From: [WILLIAM Deutscher](#)
To: [Turcott, Mike \(UTC\)](#)
Cc: [Mike Beehler](#); [Mary Kay Nelson](#)
Subject: Re: SR-6 Signal Project - Addendum to WSDOT Petition
Date: Tuesday, May 31, 2022 5:45:52 PM
Attachments: [image001.png](#)
[TR-220367 - Second Petition Attachment - SR 6 - 848701J.pdf](#)

On 5/25/2022, the WSDOT submitted to the UTC an addendum to its original petition for the SR-6 signal project. The addendum (attached) clarified certain technical details of the project that were missing from or not clearly explained in the original petition, and was submitted at the request of UTC staff. Please review the attached document and advise if the railroad is in concurrence with the addendum.

HWY 6 - MIDVALE SIGNAL

HWY 6 - MIDVALE SIGNAL
GUARDRAIL CONSTRUCTION PLAN

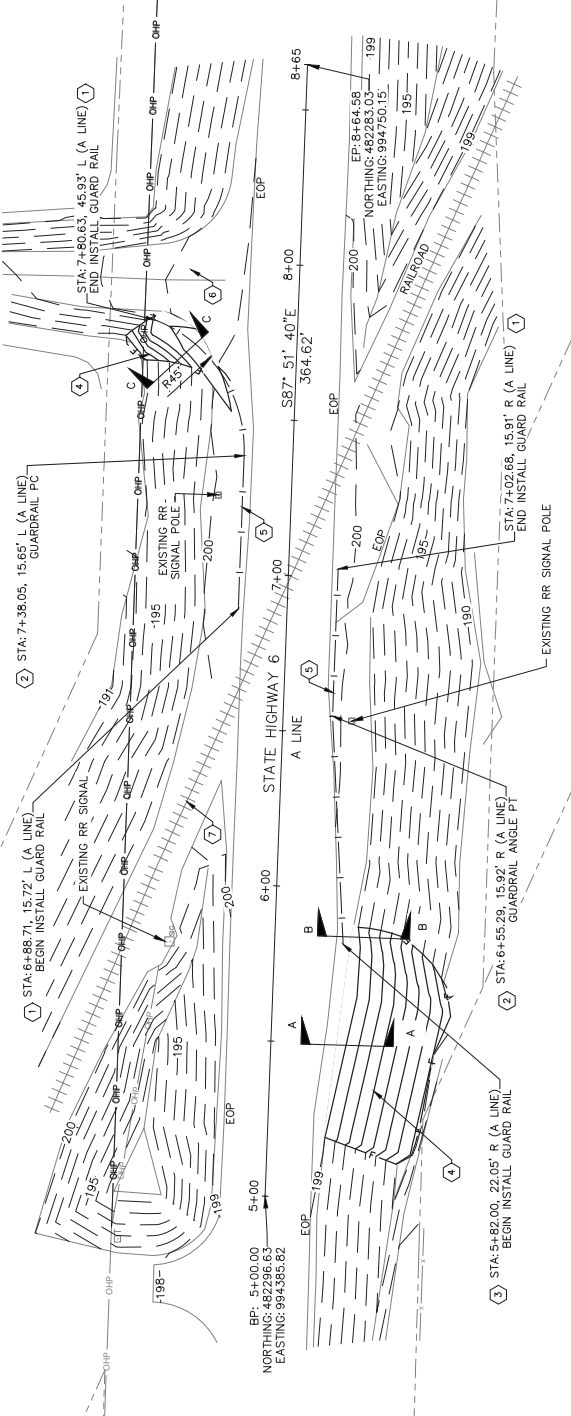
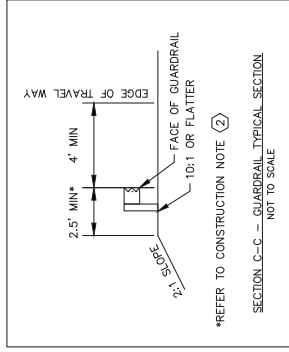
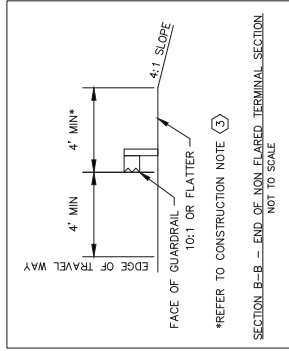
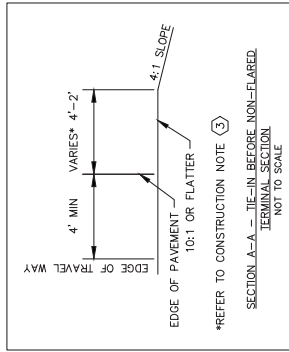
- The petition attachment only covers signal design. Could you please provide design drawings that include the elements described in Section 8 of the petition form, including: **see attached plans**

- Guardrail – **see attached plans**
 - Signage. – **see below**
- Does "install new signs" include replacement of existing advance warning signs, crossbucks, and ENS? Any other signs? (These should be indicated on the sign plan.) **Existing signage will be replaced with new crossbucks and warning signs. Current field installed advanced warning signs will be replaced with new. New bungalow will be provided with new ENS signs as well.**

- 1 INSTALL ANCHOR TYPE 10 PER WSDOT STD PLAN C-23.60-04.
- 2 INSTALL BEAM GUARDRAIL TYPE 31 PER WSDOT STD PLAN C-20.10-07.
- 3 INSTALL BEAM GUARDRAIL TYPE 31 NON-FLARED TERMINAL PER WSDOT STD PLAN C-22.40-06. FINISH AS PER METHOD B.
- 4 COMPACTION: REFER TO STD. SPEC. 2-03.3(14)C METHOD B.
- 5 FOR INSTALLATION OF GUARDRAIL AT A RAIL ROAD CROSSING REFER TO CASE 3-31 OF WSDOT STD. PLAN C-20.14-04.
- 6 DRIVEWAY ACCESS SHALL BE ACCOMMODATED DURING ALL OPERATIONS.
- 7 MAINTENANCE SHALL BE RESPONSIBLE FOR MAINTAINING DRIVEWAY ACCESS THROUGHOUT THE DURATION OF CONSTRUCTION.

RAILROAD CROSSING LAYOUT
STANDARD PLAN M-11.10-03

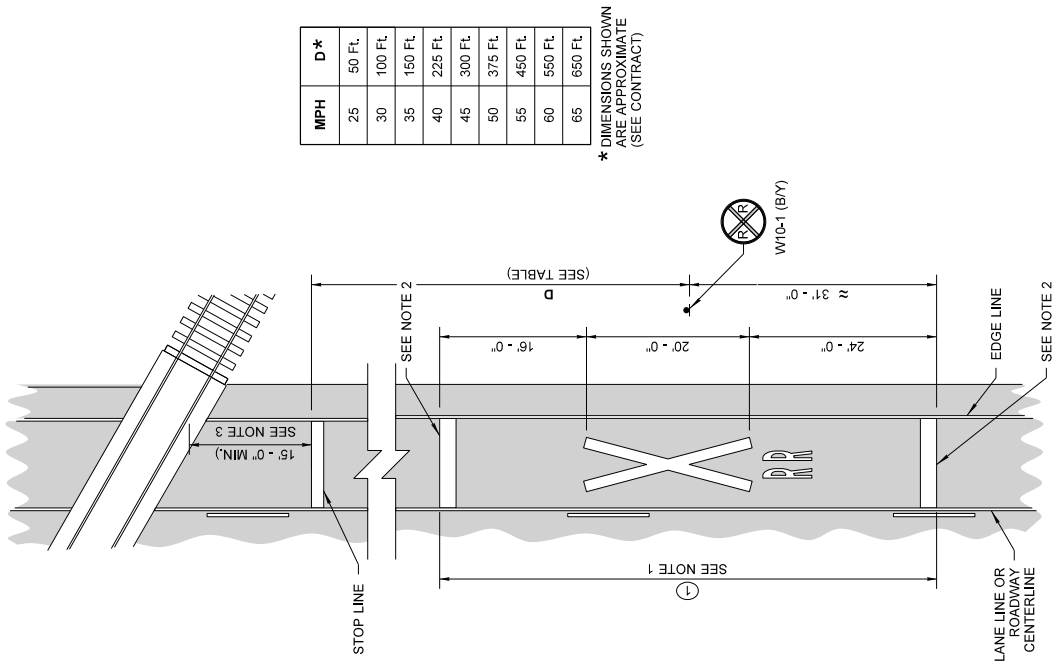
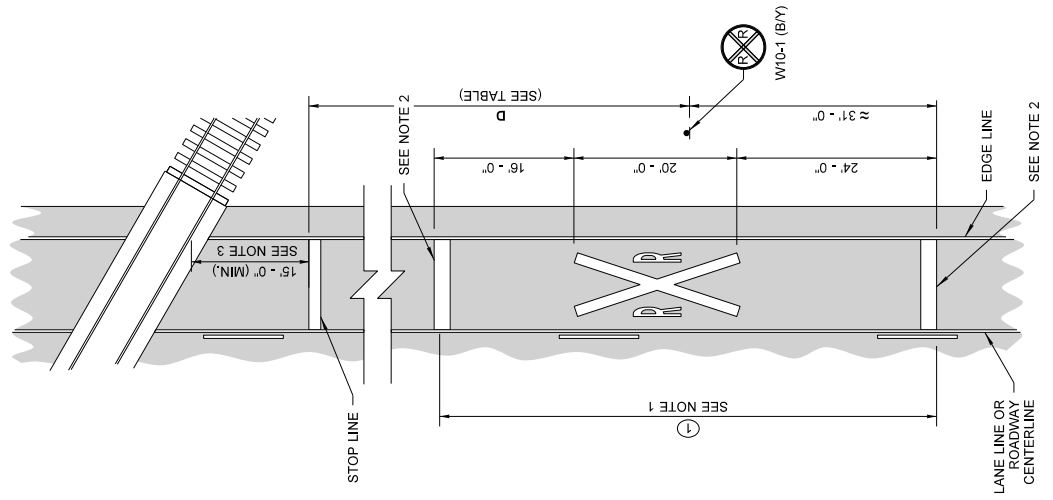
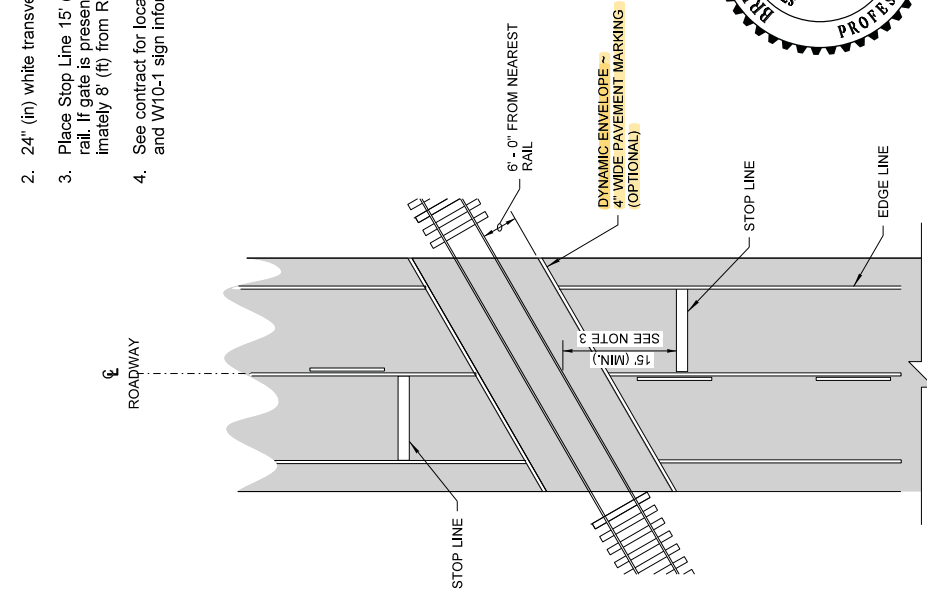
- Pavement – **There is no change to the pavement or crossing surface**
 - Pavement markings – **pavement markings will remain the same but be refreshed as needed (construction tends to tear them up). All markings will be in accordance with WSDOT standard plan attached.**
